City of Franklin

Meeting Agenda

Historic Zoning Commission

Monday, September 14, 2026

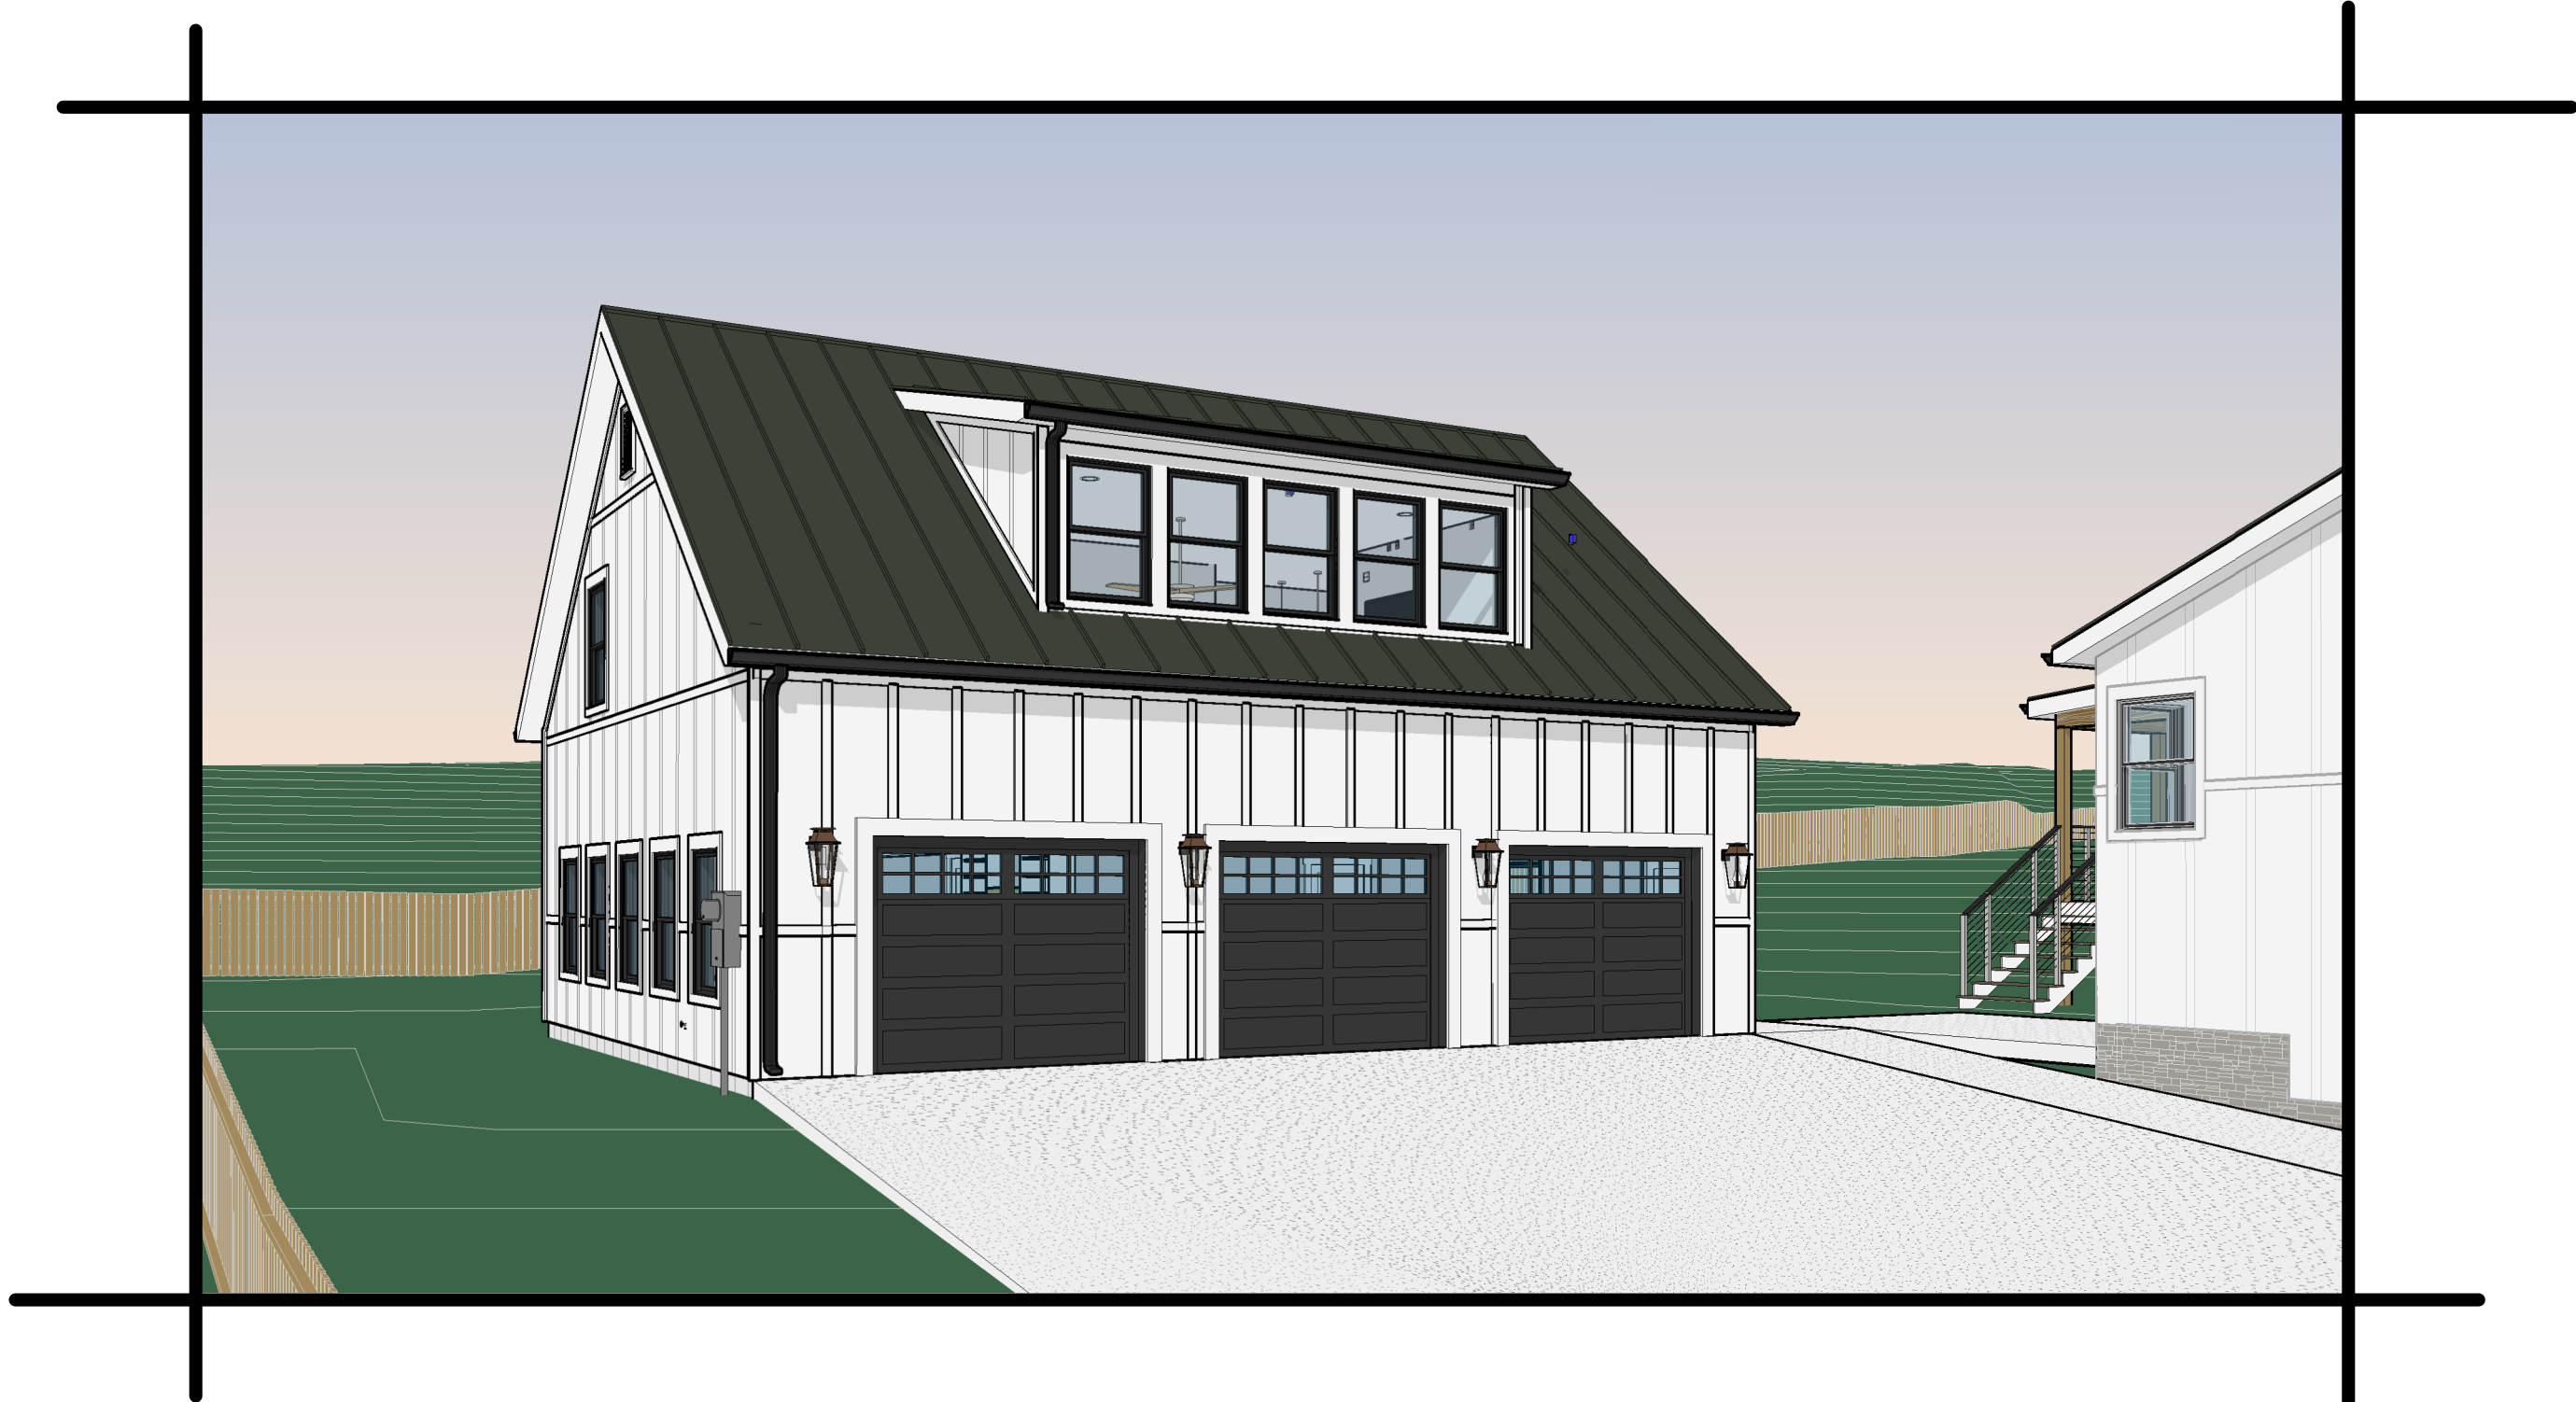
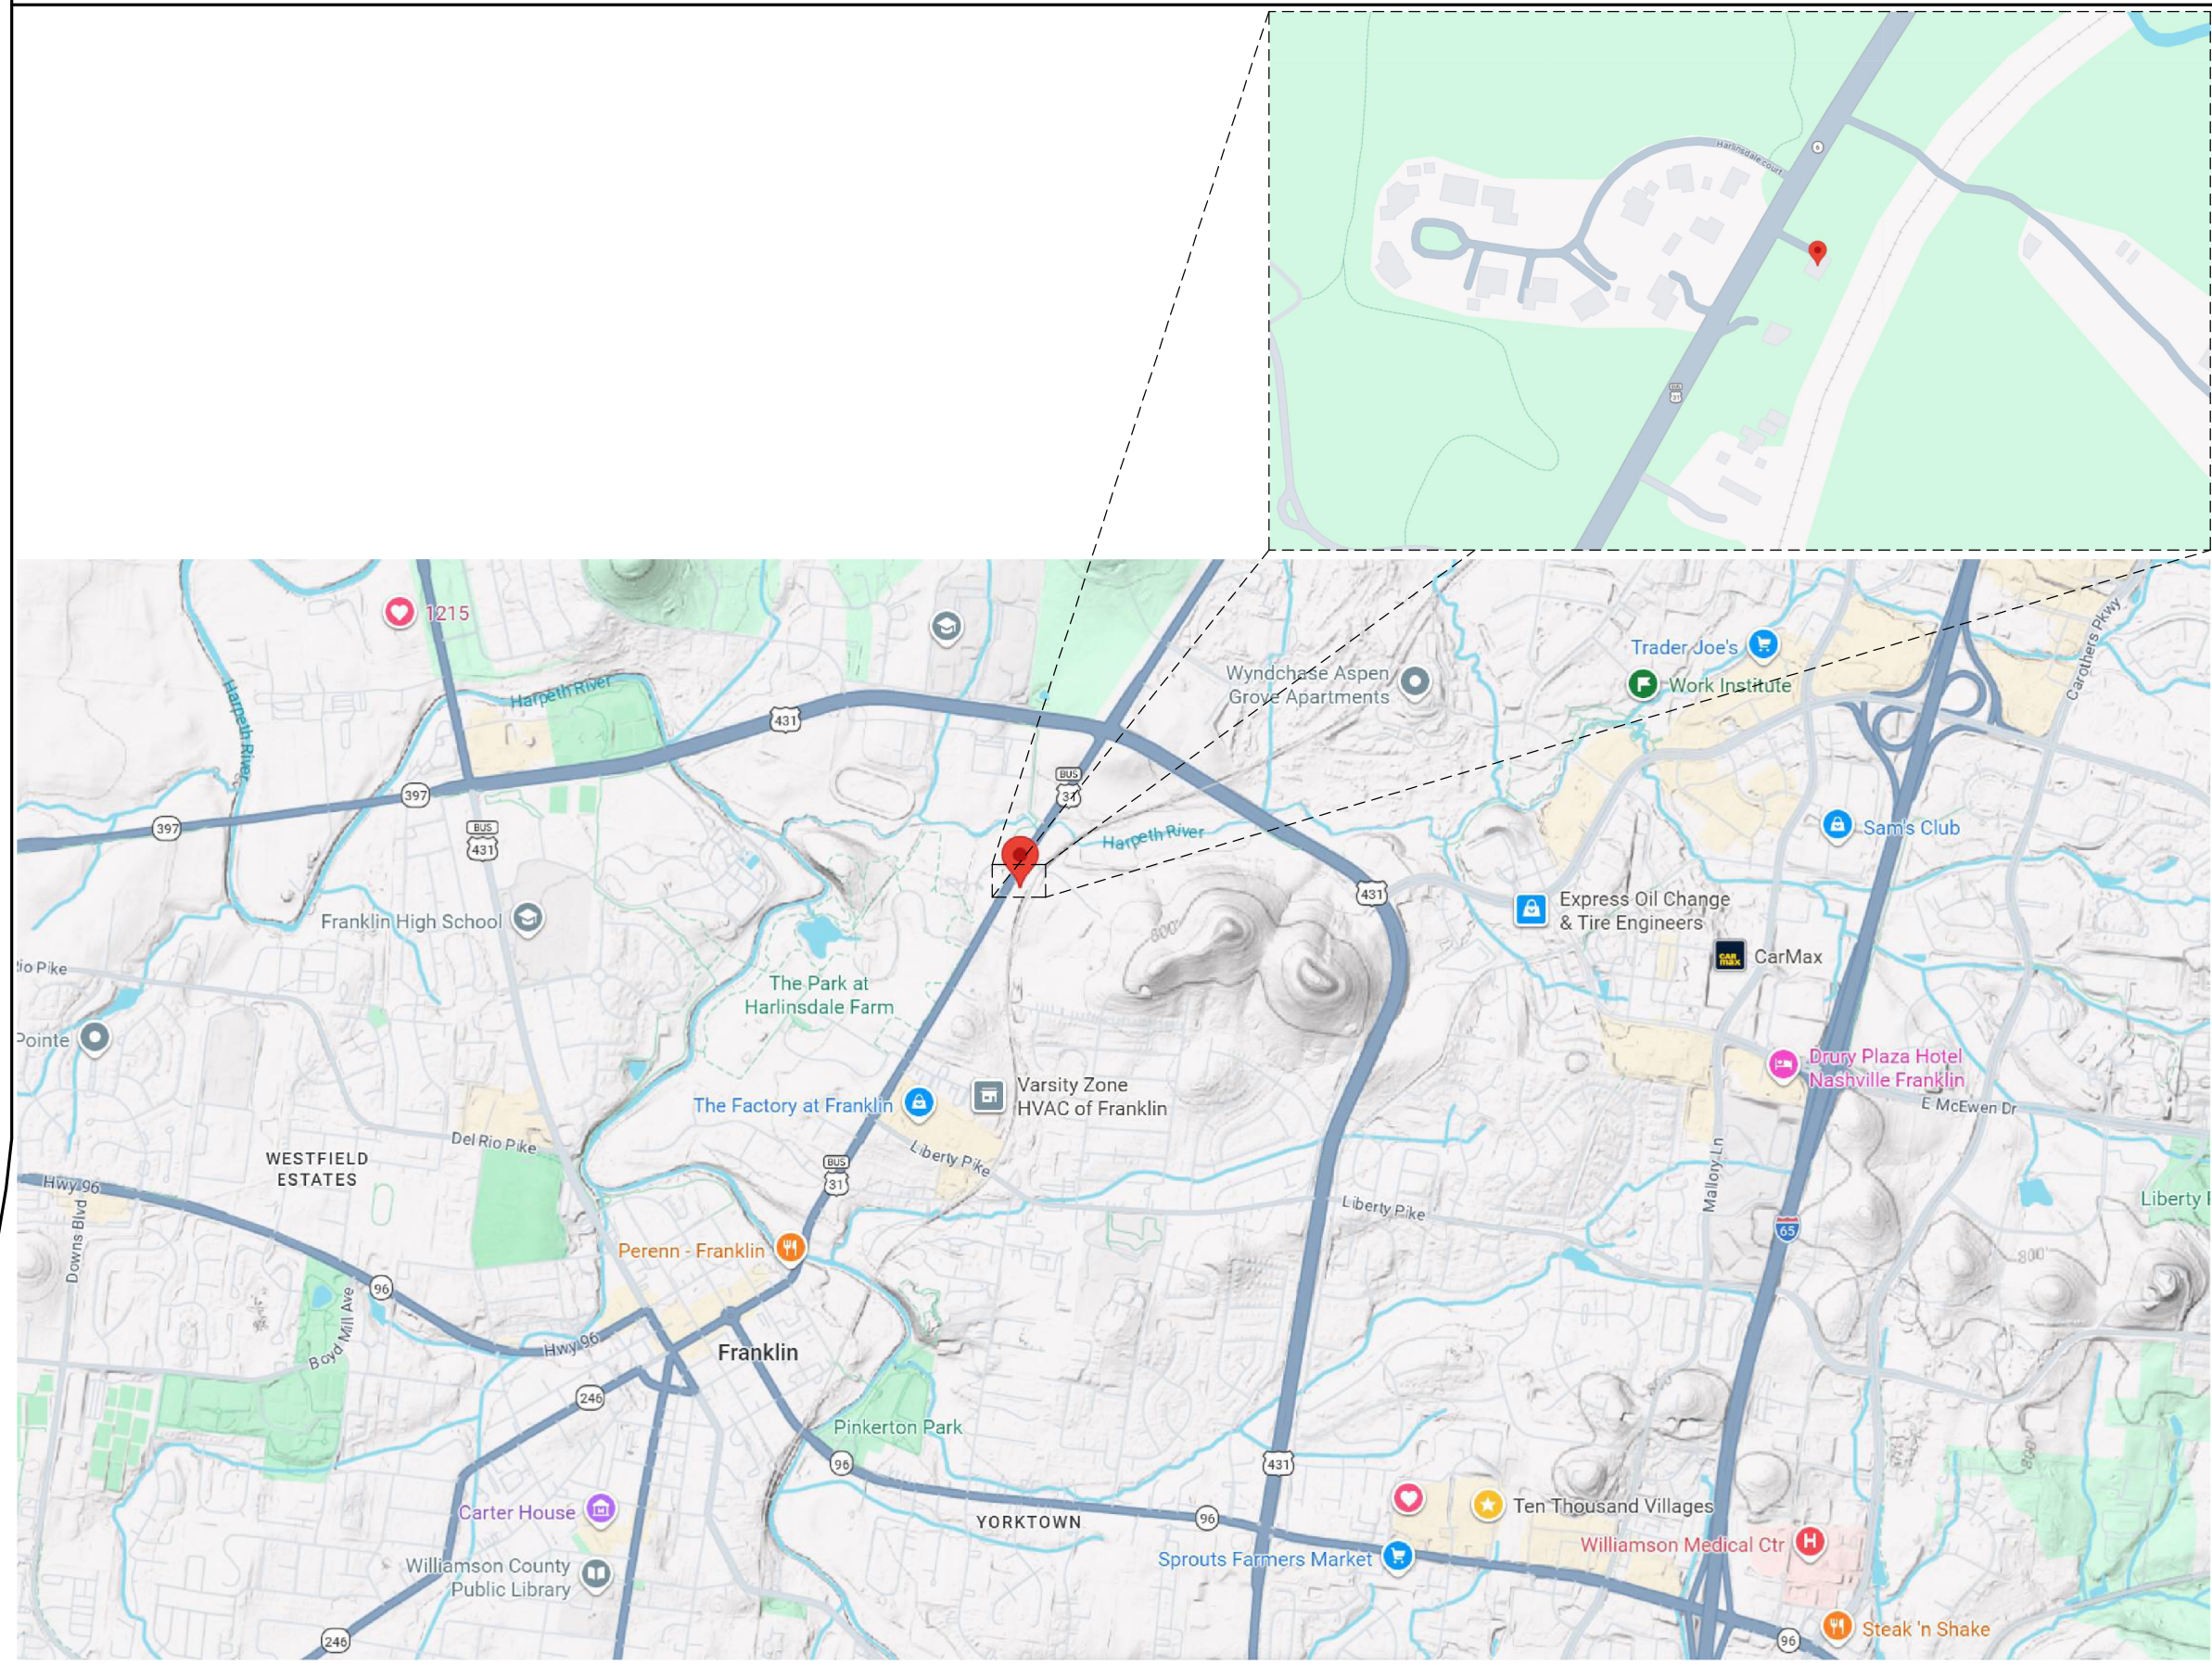
The proposal includes a request for the addition of a covered porch at the rear of the building and a change to the roofing material. The proposed covered porch is 16' by 21', or approximately 336 sq. ft., and consists of standing seam metal roofing, wood porch elements, and horizontal metal cable railing. The covered porch will be centered within the rear gable. The existing roof features asphalt shingles and is proposed to be replaced with black standing seam metal roofing. The Guidelines recommend the following for alterations on non-historic residential buildings:

The proposal includes a request for the construction of a 1 ½ story accessory structure located behind the rear plane of the principal building. The structure features a side gable form, shed dormer, and three garage bays. The structure is proposed to have a footprint of 1,140 sq. ft. The upper story has a footprint that is approximately 60% of the lower footprint. The proposed total height is 25'7". The principal building has a total height of 27'5" and is approximately four feet lower in grade, so the accessory structure will be positioned at a higher grade behind the principal building.

The gutter specifications were not included. However, if gutters are proposed, K-style or Ogee gutters would be appropriate for the age of the building. The lighting specifications and design were not included in the plans and should align with the Guidelines.

- Note: The proposed office does not meet the minimum area or dimension requirements for habitable space per the 2024 IRC. Habitable rooms shall have a floor area of not less than 70 square feet and shall be not less than 7' in any horizontal dimension.

1. The rear-covered porch railing must be oriented to be more traditional and in keeping with the style of the principal building and must match the railing seen on the front of the building. The specifications must be submitted to the Preservation Planner prior to issuance of a building permit.

3. The windows must have a historic profile and dimensions and consist of either wood or a composite material with the appearance of wood. The window, door, and garage door specifications must be approved by the Preservation Planner or the HZC prior to issuance of a building permit.

4. The lighting specifications must return to the Preservation Planner prior to purchase and installation for review and approval.
5. The light fixtures must use illumination with a warm white light which does not distort the color of building materials or finishes and avoid using colored bulbs or gels, or lighting with changing colors.
